Mitigation Plan
Horne Creek Tributaries Mitigation Project
Surry County, North Carolina
FINAL VERSION

NCDEQ DMS Project Identification # 100026
NCDEQ DMS Contract # 7181
Yadkin River Basin (Cataloging Unit 03040101)
USACE Action ID Number: SAW-2017-01510
Contracted Under RFP # 16-006993

Re: NCIRT Review and USACE Approval of the Horne Creek Tributaries Mitigation Plan; SAW-2017-01510; NCDMS Project # 100026

SUBJECT: Horne Creek Tributaries Mitigation Site - NCIRT Comments during 30-day Mitigation Plan Review

SHEET NUMBER
10

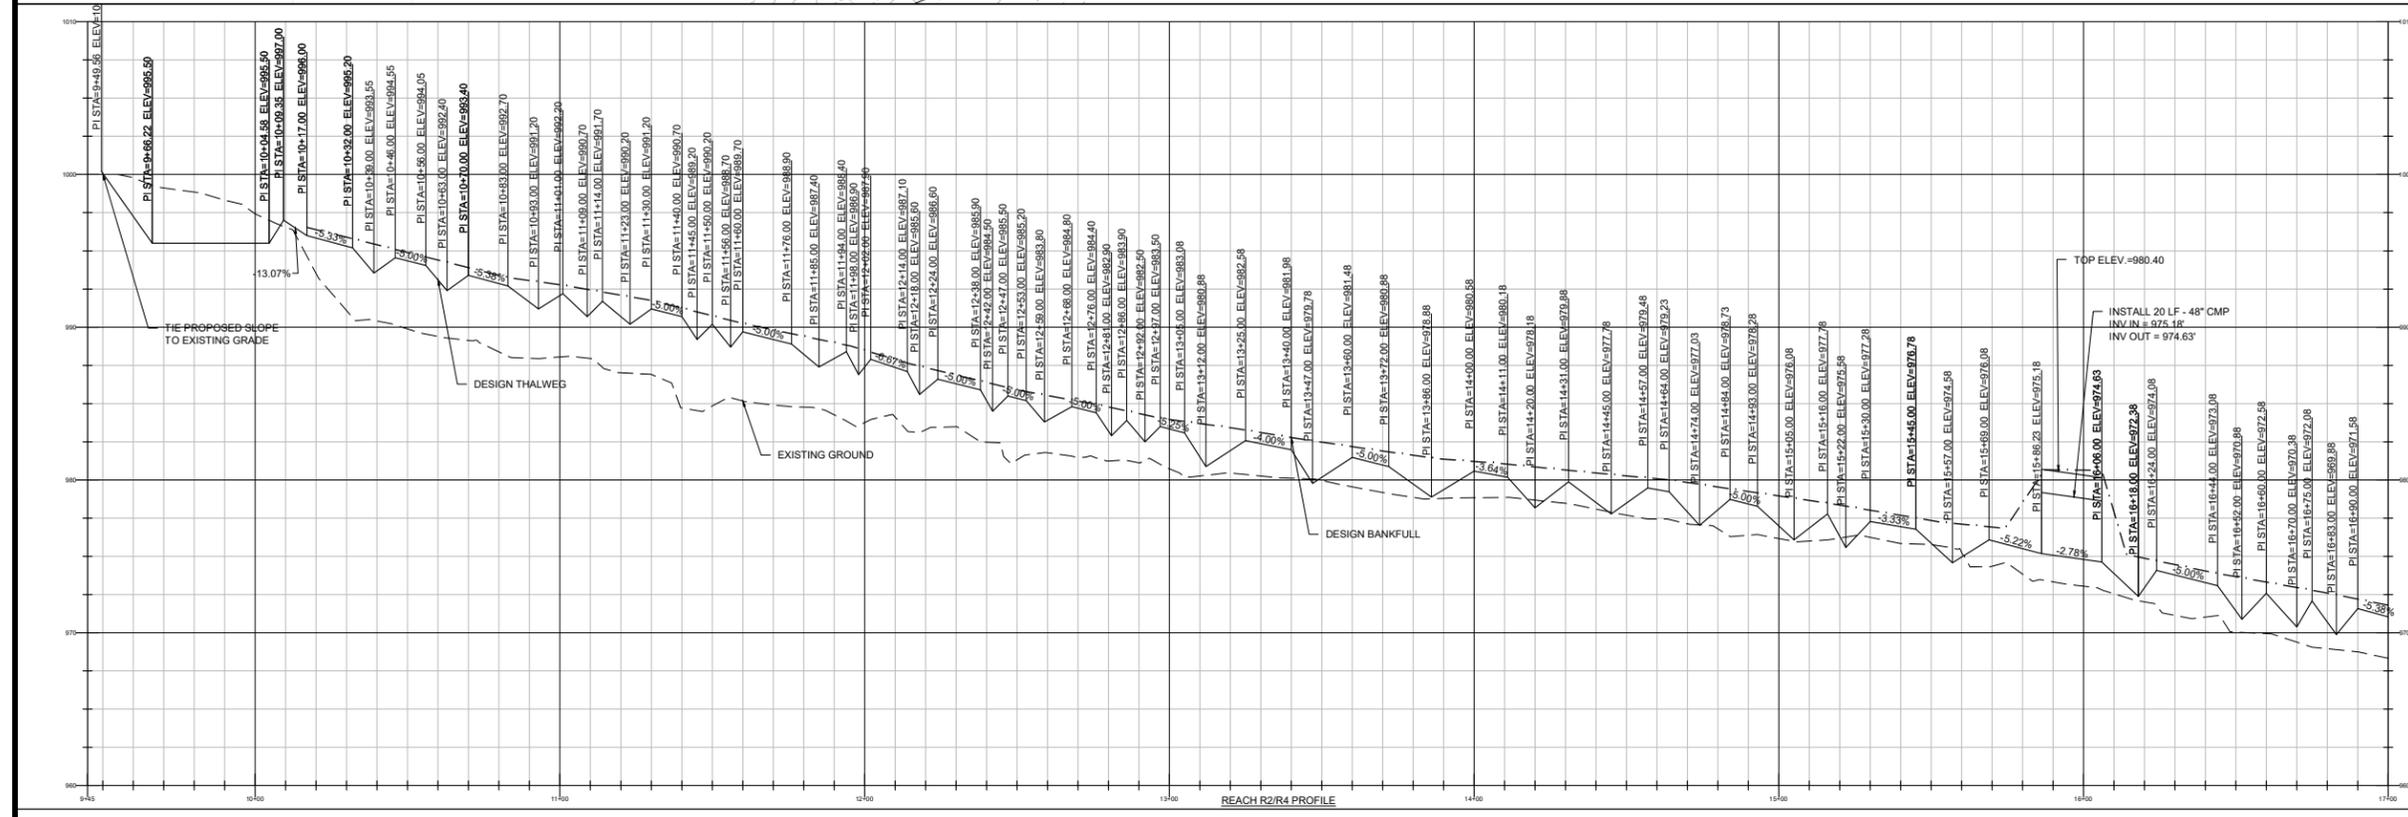
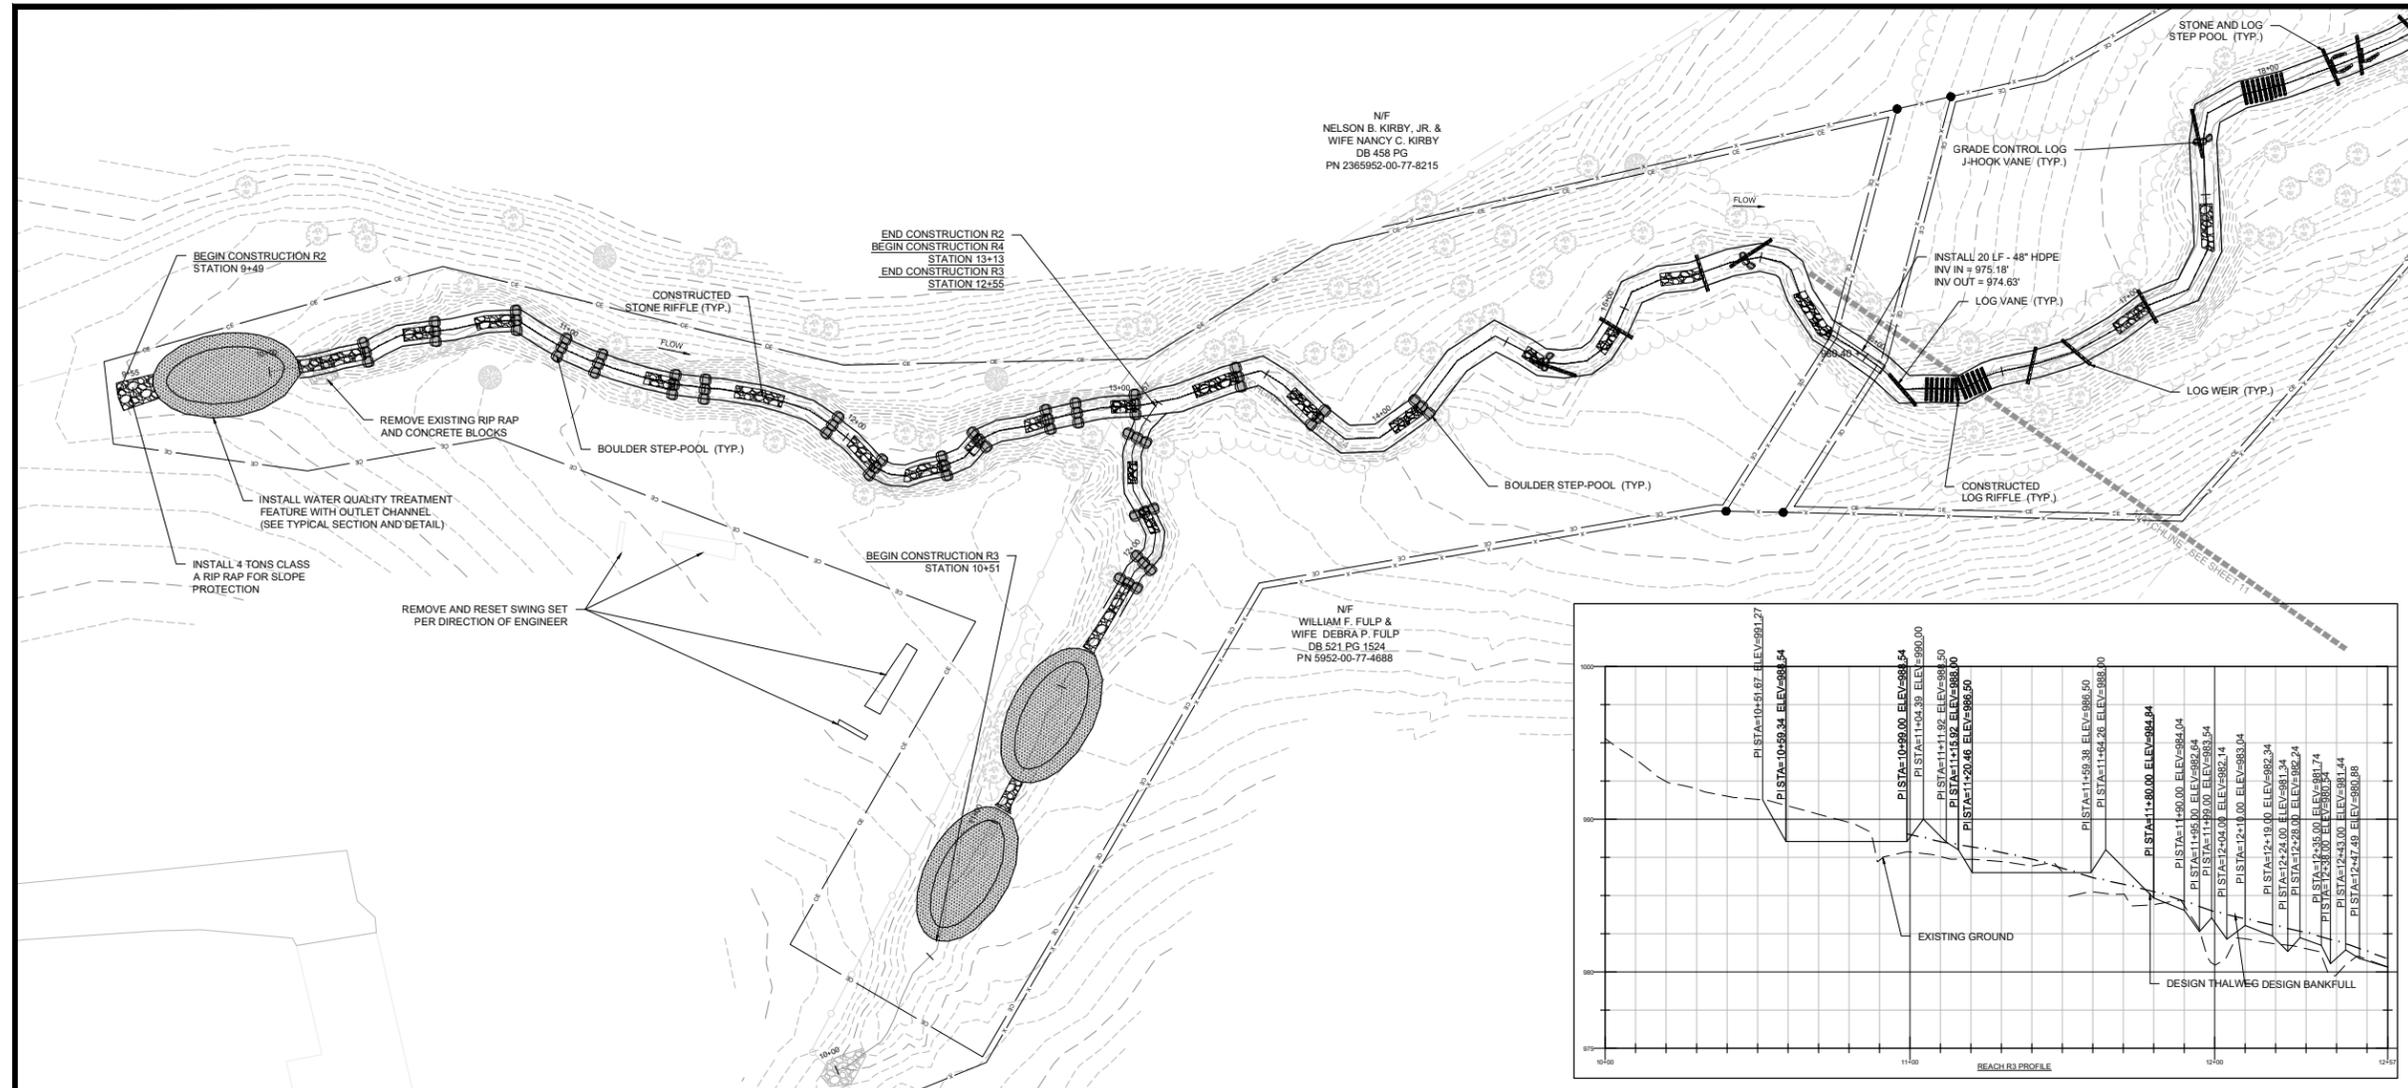
8. Design sheet 10 - DWR would like to see the flow gauge moved to station 12+00 on reach R2.

2. Design Sheet 10: It appears that there are three BMPs within the easement. Please ensure that these features are not in the jurisdictional areas as it is unclear on the maps and design sheets, and that their short-term maintenance is discussed in the text, if any is necessary. Response: As discussed during the IRT post contract site visit and meeting minutes, the water quality improvement features are located above the streams jurisdictional determination (origin points) and are designed to be self-maintaining, therefore should not require annual maintenance as cattle are excluded and buffer vegetation becomes established. Please refer to Appendix 9 WOTUS information for the USACE PJD correspondence, including stream and wetland location/origination maps.

Response: The proposed flow gauge has been moved from the R2/R3 confluence (station 13+13) to approximate station 12+00 on the design plan sheet 10 and figure 9.
